Memorandum

date: October 23, 2003
to: E. Lessard; Chair, LESHC
from: Congwu Du, Micro-MRI Facility
subject: Summary of Responses to Safety Committee Comments

subject: **Operational Readiness Evaluation (ORE) Report – Building 490, Micro MRI Facility, Full Operation**

(BUILDING 490, MICRO MRI FACILITY, FULL OPERATION)

Table 1
Animal MRI ODH Classification Summary

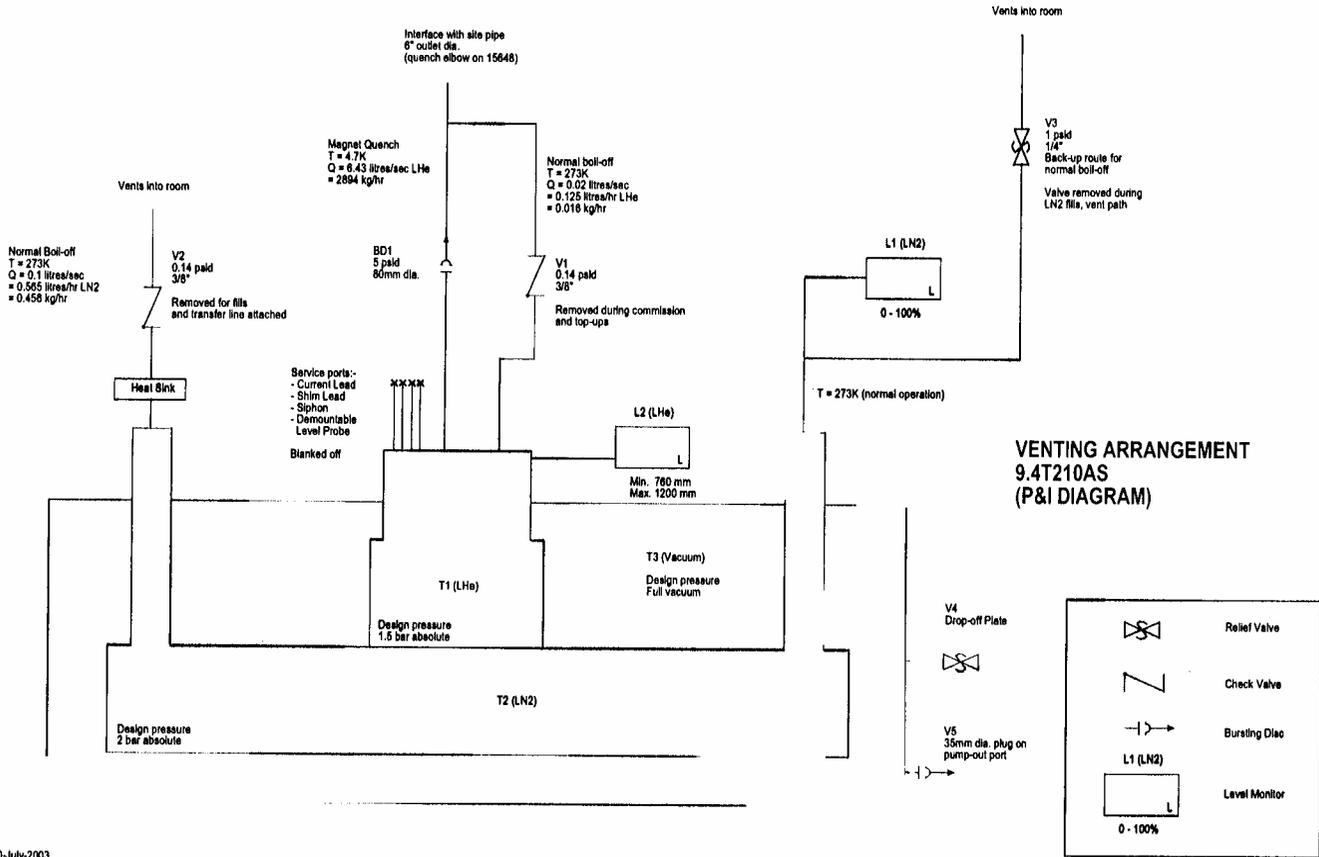
It is recommended that the facility be posted ODH 0 when it contains LHe and/or LN₂ and ODH 1 when performing initial filling or routine top-offs.

Thus a quench event results in a required MRI room posting of ODH 0 because the fatality factor (1) times the frequency of the event (8×10^{-8} /hr) results in a fatality rate that is $<10^{-7}$ /hr.

Thus a magnet-can failure results in a required MRI room posting of ODH 0 because the fatality factor (1) times the frequency of the event (5×10^{-8} /hr) results in a fatality rate that is $<10^{-7}$ /hr.

If the quench event were to follow this excessive heating by the bayonet, the probability of a release of helium into the room via a failed quench exhaust line would be $(1 \times 10^{-3} \text{ per demand})(4 \times 10^{-3}/\text{demand})^1$ or $4 \times 10^{-6}/\text{demand}$. The rate of helium release would be so high that the fatality factor would be 1. Conservatively ignoring any emergency actions by the person in the room (i.e., removal of the bayonet or escape from the room), the fatality factor would be equal to $4 \times 10^{-6}/\text{demand}$. This value is between 10^{-5} and 10^{-7} , thus an ODH classification of 1 is needed during routine filling operations.
